Access Compliance Report

Public Rights-of-Way

Intersection ID: 7038	Main Street: BROOKWOOD_RD	Cross Street: WOODWIND_ST	Location: NW
ADA ID: 76A4D091AE1F	Ramp Type: Perp	Initial Pass/Fail: Fail	Overall Compliance: No
		Severity Score: 10

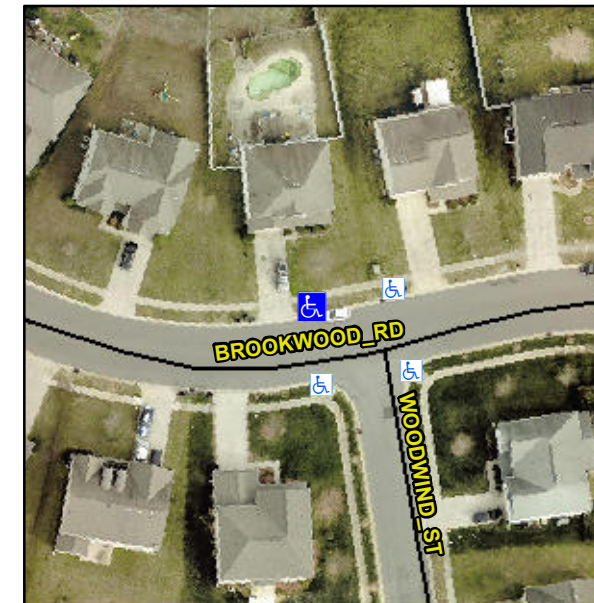
Not Found, R304.5.1

Compliance	Description	Data	Compliance	Description	Data
N/A	Ramp Length (in)	72.0	Yes	Ramp Slope (%)	6.0
No	Ramp Width (in)	47.5	Yes	Ramp XSlope (%)	2.4
N/A	Flare Type LT	N/A	N/A	Flare Type RT	N/A
N/A	Flare Slope LT (%)	N/A	N/A	Flare Slope RT (%)	N/A
N/A	Flare Traversable LT?	N/A	N/A	Flare Traversable RT?	N/A
N/A	Landing Length (in)	N/A	N/A	DWS Provided?	N/A
N/A	Landing Width (in)	N/A	N/A	DWS Contrast?	N/A
N/A	Landing Slope (%)	N/A	N/A	DWS Length (in)	N/A
N/A	Landing X Slope (%)	N/A	N/A	DWS Full Width?	N/A
N/A	Landing Curb? (Y/N)	N/A	N/A	DWS Offset (in)	N/A
N/A	Shared Landing?	N/A			
N/A	Gutter Ponding?	N/A	N/A	Gutter Slope (%)	N/A
N/A	Gutter Lip Ht (in)	N/A	N/A	Gutter X Slope (%)	N/A
N/A	Painted X Walk1?	No	N/A	Painted X Walk2?	N/A
	X Walk 1 Direction	To S		X Walk 2 Direction	N/A
N/A	X Walk 1 Width (in)	N/A	N/A	X Walk 2 Width (in)	N/A
	X Walk 1 Slope (%)	4.2		X Walk 2 Slope (%)	N/A
	X Walk 1 X Slope (%)	3.0		X Walk 2 X Slope (%)	N/A

Remove & Replace Entire Ramp.
